August 26, 2019

In Reply To: Skillem Integrated Resource Restoration Project EA

On behalf of the American Forest Resource Council (AFRC) and its members, thank you for the opportunity to comment on the Skillem Project.

Figure 1: Stand between the 27 road and the 990 road from the 27 road.

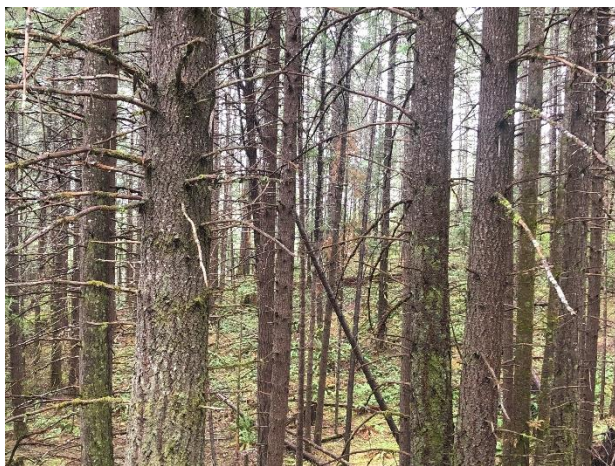
The consideration of active management on every acre of appropriate land, regardless of its land allocation, is important to our membership as each year's timber sale program is a function of the treatment of aggregate forested stands across the landscape. The EA states that the District is proposing treatment on about 5% of the project area (11,400 acre project area and 646 total commercial treatment acres). This percentage is typical of many Forest Service vegetation management projects and although AFRC would like to see the agency treat a higher proportion of the landscape, we understand the multiple directives and land management restrictions in place that make doing so difficult. We appreciate the Tiller RD for adding unit 400 to the Project. In AFRC's scoping comments we identified three stands along the 27 road in need of treatment. Stand 400 falls within two of the areas we identified. AFRC also identified a stand between the 27 road and the 990 road (Figure 1 & 2). During the Skilleen public field trip those present walked a portion of the 990 road from the 27 road. This section of the road has been proposed for decommissioning, but multiple participants on the field trip expressed concern with a full decommissioning of the road due to limited resource degradation and the usefulness of the road for hunting. We believe this portion of the road will be necessary to treat the identified stand in our scoping comments and should be considered for storage instead.
